**REMARKS:**

This amendment corrects an ambiguity found during a final review of this allowed application. Changes to the specification and drawings seek to clarify that the first voltage follower is comprised of first differential amplifier 118 and voltage divider 108, the second voltage follower is comprised of second differential amplifier 128 and output stage 122, and the feedback paths of the first and second voltage followers.

FIG. 1

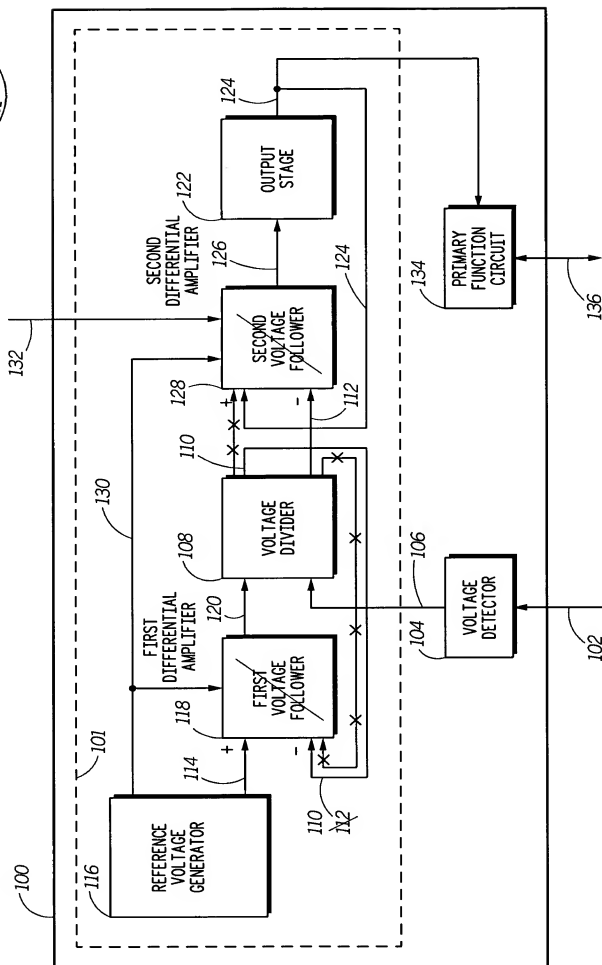
One of ordinary skill in the art would understand that circuits 118 and 128, shown in Figures 1, 3 and 5 as originally filed and described, are differential amplifiers and not voltage followers. Moreover, it is known that the combination of a differential amplifier circuit with a voltage divider circuit, shown for example in the original drawings as blocks 118 and 108, forms a voltage follower. The amendment to the specification simply clarifies this.
